**RE: SUBMISSION ON STATE SIGNIFICANT DEVELOPMENT
APPLICATION: SSD-10464 – 50-52 PHILLIP STREET, SYDNEY**

Jones Lang LaSalle NSW Pty Ltd (JLL) as Managing Agent, has prepared this submission letter on behalf of Aurora Place Investments Pty Ltd as the landowners of the site at 88 Phillip Street, Sydney, which is legally described as Lot 101 on DP1011617. The site and the asset are recognised as Aurora Place. The submission relates to the proposed Concept State Significant Development Application for the land at 50-52 Phillip Street, Sydney (SSD-10464).

Figure 3 Private View Impacts

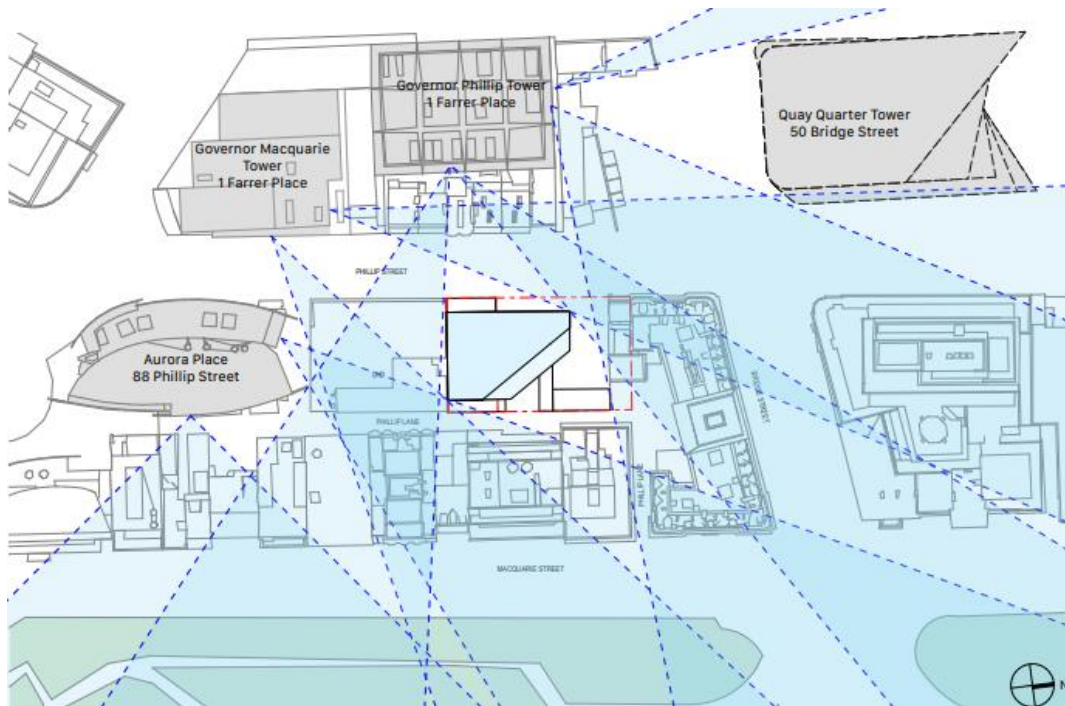
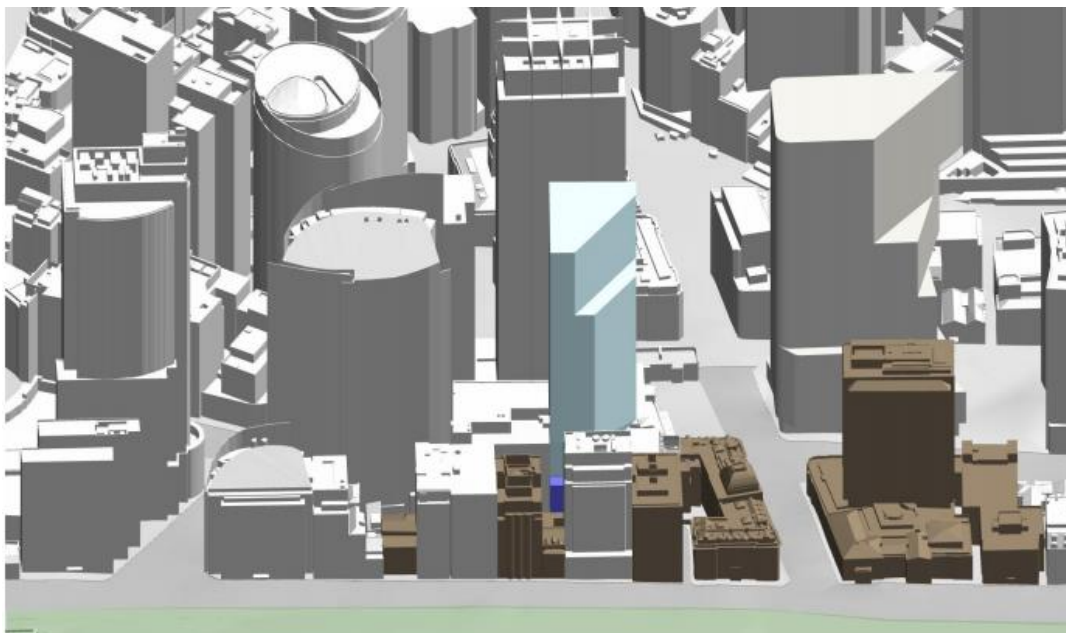
From the images above it appears as though the proposed building envelope could have adverse view impacts on Aurora Place which would impact significantly on the amenity of existing tenants. In particular, the proposal appears as though it could obscure the significant existing view corridor from Aurora Place to Sydney Opera House and Harbour (toward the north) and potentially the view corridor to Circular Quay along Phillip Street. Potential amenity impacts such as these further hinder the incentives for the workforce of Aurora Place return to working in the CBD and has spill over effects on surrounding local businesses.

It is requested that further information on view impacts and an updated VIA that adequately analyses and assesses private view sharing impacts to surrounding developments such as Aurora Place as per the SEARs issued by DPIE.

Figure 4 Comparison of the Proposal and an SDCP Compliant Envelope

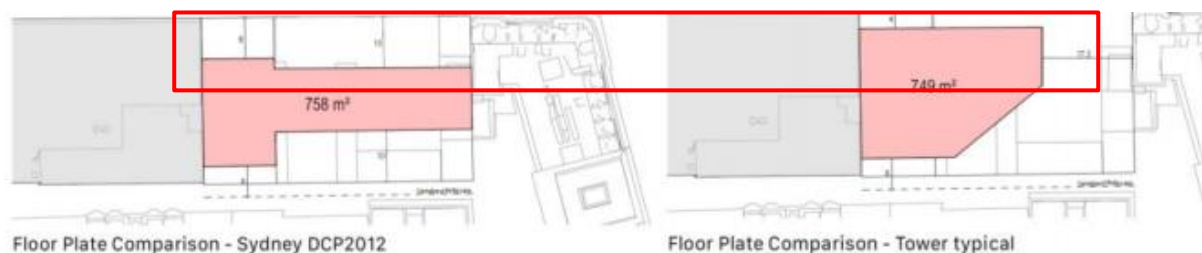
In particular, the proposal is non-compliant with the 8-metre weight average setback control to Phillip Street and the 10 metre setback requirement to the State heritage listed building at 50 Phillip Street. The applicant has provided a comparison of an SDCP compliant envelope and the proposal in which we have marked up the non-compliance (refer figure below).

In our view, the proposed non-compliant envelope which breaches the required Phillip Street and heritage item setback could adversely impact on the amenity of Aurora Place situated to the south in terms of reducing solar and daylight access (particularly overshadowing to the western façade), and impacting upon the existing view corridor to the north along Phillip Street (as previously discussed).

There are also concerns that the Phillip Street setback non-compliance results in a longer building interface which presents to the southern boundary and effectively Aurora Place. In addition to the beforementioned amenity impacts, this could result in additional privacy impact considerations for future detailed designs.

As such, it is requested that the applicant and DPIE give further consideration to a compliant building envelope (in terms of setback) and mitigating adverse overshadowing, daylight, and view sharing impacts as this will provide improved amenity to Aurora Place.

Figure 5 CSPP 2020 SAP Non-Compliances (outlined in red)

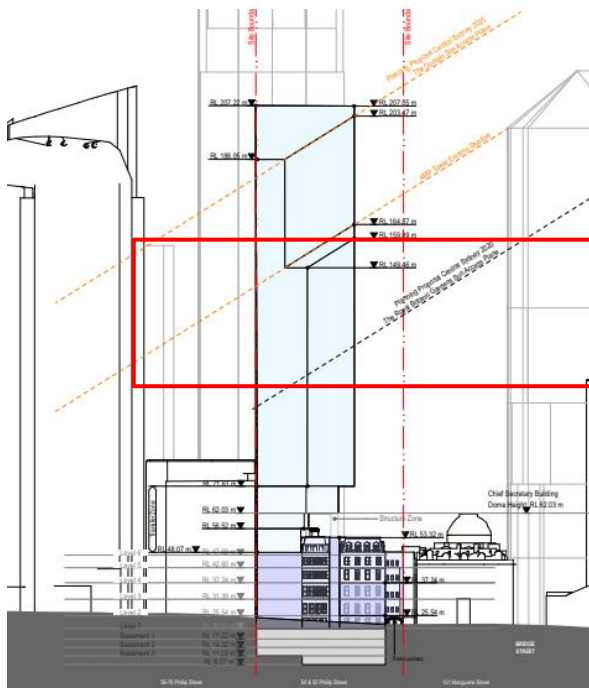
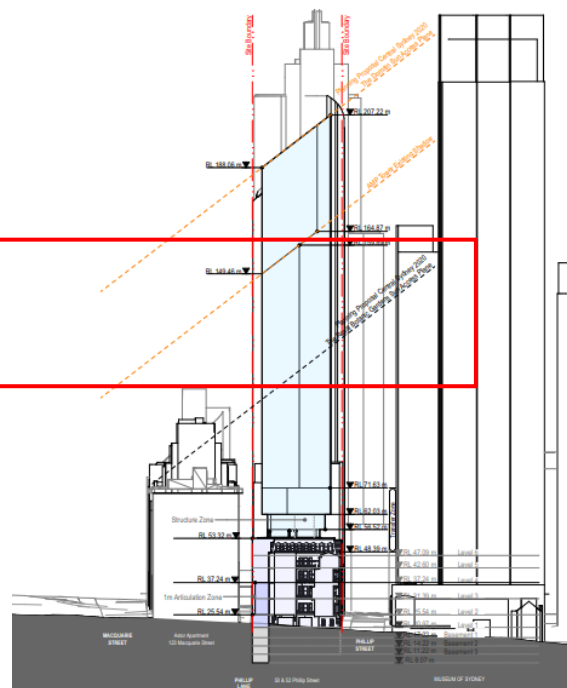
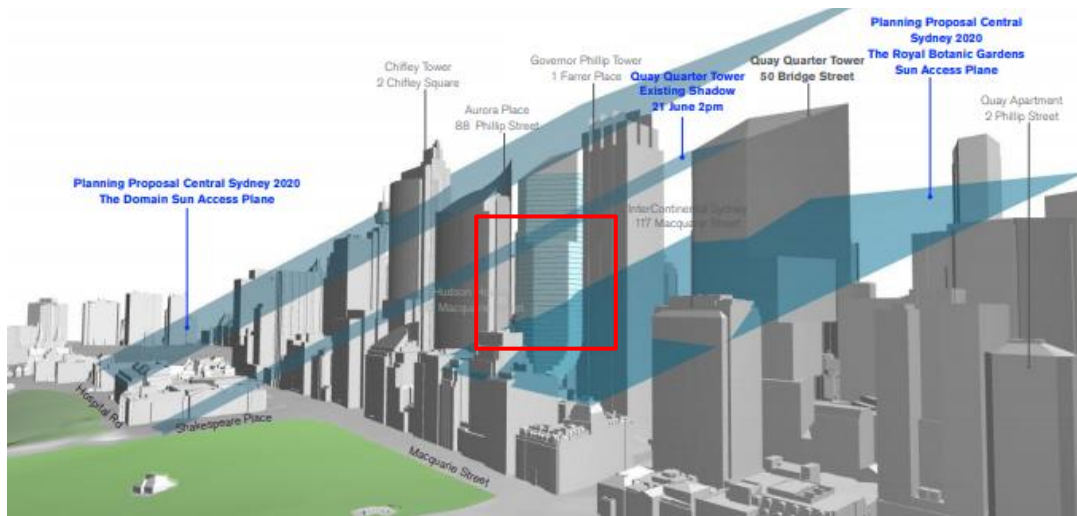
The proposals non-compliance with clause 6.17 of the SLEP and CSPP Royal Botanical Garden SAP are illustrated in the figure below.

The non-compliances with both the SLEP and CSPP SAP controls could cause adverse amenity impacts to existing tenants at Aurora Place with regards to overshadowing. The proposed building envelope and Aurora Place are similar in height. As such, it is considered that any reduction in height to achieve compliance with the SLEP SAP controls will improve solar and daylight access to Aurora Place, particularly to the upper floor tenancies.

It is requested that the applicant provide information for their non-compliances with the SLEP controls, particularly in terms of providing an overlay which demonstrates the height breach (similar to Picture 5 above but for the SLEP controls). In addition, it is requested the applicant further consider complying with these controls to enable greater solar and daylight access for Aurora Place, thus improving the amenity for existing tenants.
